PANEL DETAIL

APPROVED BY	PREPARED BY-	E. C. RAILWAY	APPROVED	CHECKED					DRAWN.	C.R.S. SANCTION	SCALE			SIP No.
(D.K. VERMA) DY.COM/Plg/ECR/HJP. f COM/ECR/HJP	IT SYSTEMS, PATNA-14	पू. म. रेल DHANBAD DIVISION	(P.K. DAS) CSTE/Plg/ECR/HJP. CHIEF SIGNAL & TELECOM.ENGINEER/E.C.R./HJP	DY.CSTE/W/DESIGN/HJP	S.S.T.E./HQ/HJP	A.S.T.E/HQ/HJP	S.E./SIG/HQ/HJP	S.S.E./SIG/DRG/HJP	JE-II/DRG	NO. DATE:-	LONGITUDINAL:- 1cm = 10m. TRANSVERSE :- 1cm = 5m.	CENTRAL-PANEL SIGNAL INTERLOCKING PLAN (MACL. CLASS-B. STD-III) TO SUIT C.E'S DRG. NO. Y-91-2007.	महुआमिलन MAHUAMILAN	ECR/SIP/DHN/248/2006

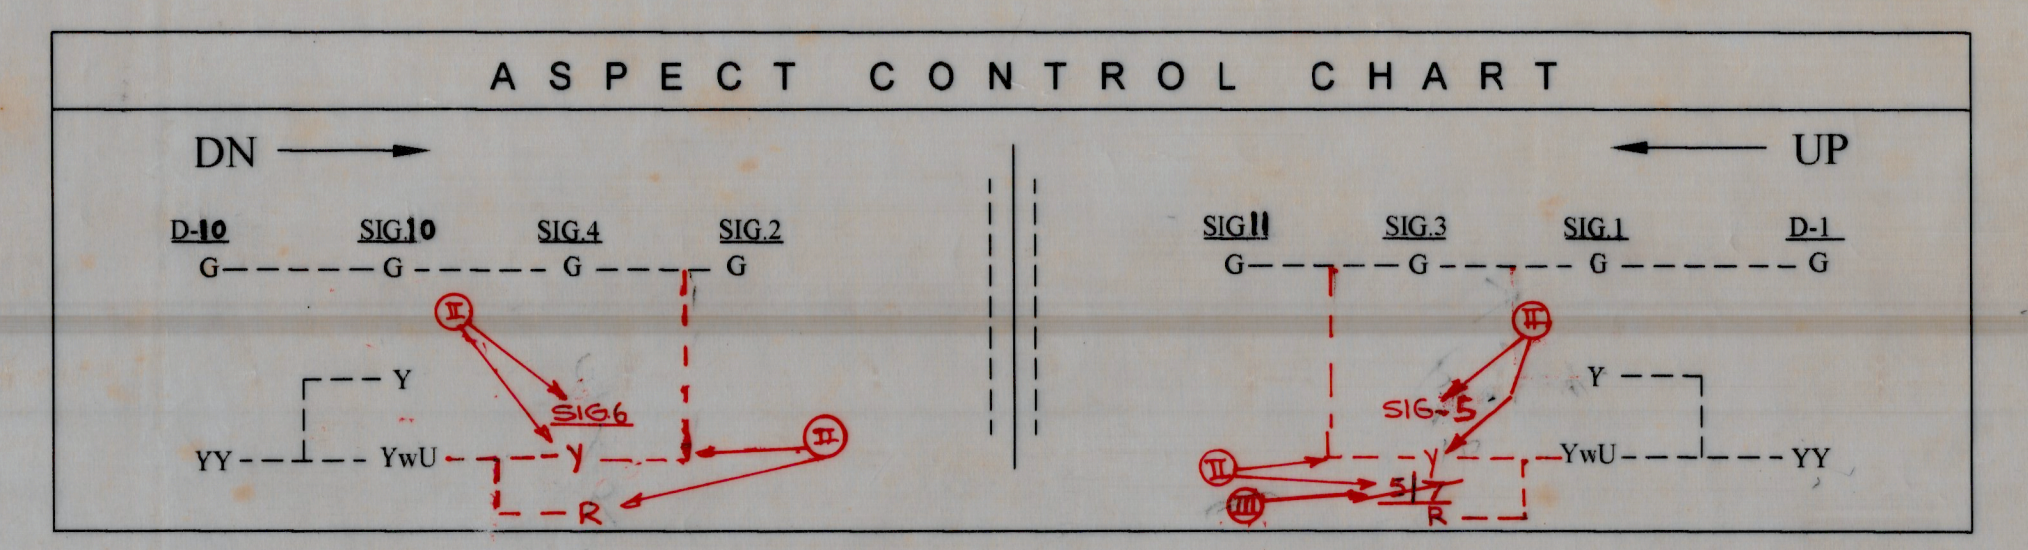
1. ABSOLUTE BLOCK SYSTEM OF WORKING WITH TORI STATION AND ~~HINDRA B.H.~~ NINDRA STATION.
2. DOUBLE LINE LOCK & BLOCK INSTRUMENT MSW/HWH TYPE WITH ~~TORI & Mc.CLUSKIEGANJ~~ NINDRA STATIONS LOCATED AT PANEL ROOM.
3. CONTROL PHONE PROVIDED AT PANEL ROOM.
4. L.V. PROVING AXLE COUNTERS PROVIDED FOR ~~MAHUAMILAN-TORI SECTION AND~~ MAHUAMILAN ~~-Mc.CLUSKIEGANJ~~ NINDRA SECTION IN BOTH UP LINE AND DN LINE AND INTERLOCKED WITH RESPECTIVE BLOCK INSTRUMENT.
5. ANGLE OF CROSSINGS ARE INDICATED.
6. UFSBI WITH BLOCK PANEL OF DOUBLE LINE AND HASSDAC WORKING WITH TORI STATION LOCATED AT PANEL ROOM.

MAIN SIGNALS :-1,2,3,4,5,6,10,11,~~7~~
CALLING-ON SIGNALS :- C-1,C-10
POINTS:- 52,53,56,57,58,~~51~~
CRANK HANDLE CONTROL BUTTONS:-,CH-2,CH-3,CH-4,CH-5,CH-6,~~CH-1~~
SIDING POINTS CONTROL BUTTON:- P-71, P-72.

ALT	DESCRIPTION	REFERANCE	CHECKED	COUNTER SIGNED	APPROVED& DATE	DATE OF COMM.	CRS'S SANC. NO. & DATE
III	(A) DELETION OF ALT II EXCEPT PROVISION OF SAND HUMP IN UP & DN LINE. (B) RESTORATION OF UP HOME SIGNAL AND DN ADV. STARTER INCLUDING TRACK CIRCUIT, GOODS WARNING BOARD TO ITS EXISTING POSITION (C) STD. OF INTERLOCKING CHANGED.	I) ESP Y-91-2007 (ALT.I) DT:-24-02-2010 II) SR. DSTE/DHN LETTER No. SG-662/I/PT. VIII DT:-5.8.10	SSE/DRG, SE/SIG, ASTE/D&D, SSTE/D&D, DY.CSTE/W/D	f COM/ECR	(राम कृपाल) CSTE/PLG		
II	I) CONVERSION OF DOWN LOOP INTO COMMON LOOP II) PROVISION OF TWO SANDED DEADEND ONE IN DOWN LOOP AND OTHER IN UP LOOP. III) ONE FACING CROSSOVER PROVIDED AT 'BRKA' END	I) TO SUIT CE'S DRG. NO. Y-22-06 ALT:-I. II) SR. DSTE/ECR/DHN'S LETTER No. SG.662/I/PT-VIII, DATED:-22/6/2009.	SSE/SIG, JE-I/D&D/H, ASTE/D&D, SSTE/D&D-III, DY.CSTE/W/D	f COM/ECR	(RAJESH KUMAR) CSTE/ECR		
I	I) CHANGE IN ESP. NO. II) P-71 MADE FS TYPE & P-72 MADE C.S. TYPE OF SWITCH MENTIONING.	I) DY. CSTE/W/DHN LETTER No SG/662/I/CON/PT-III, DATED:-16/01/08 II) CE'S DRG. NO:- Y-91-2007	SSE/S, ASTE/D&D, SSTE/D&D, DYCSTE/WD	(S.K. NAYAK) CTPM f COM/ECR	(ARUN VERMA) CSTE/PLG f CSTE/ECR

IV	ADJACENT STATION NAME CHANGED	VIDE DY CSTE/W/DHN/LT. NO-662/I/CON/PT XI DT-09/02/2014	SSE/S, JE/D, ASTE/D&D, SSTE/D&D, DY.CSTE/W/D	f.COM/ECR	(S.L. PRASAD) CSTE/S f.CSTE/ECR		
V	PROVISION OF UFSBI BLOCK PANEL WITH HASSDAC BETWEEN MAHUA MILAN-TORI	IN CONNECTION OF MAKING SIMILARITY WITH APPROVED SIP OF TORI NO-ECR/SIP/DHN/247/2017	SSE/S/C/MHX, (NEHAL SHAH) DSTE/C/MHX, (GAUTAM GUPTA) DSTE/C/MHX, (B.K. SINGH) DY.CSTE/C/S/MHX	(S. KUMAR) CTPM f. COM	(RAJESH KUMAR) CSTE/C/S/MHX f. CSTE/ECR/HJP
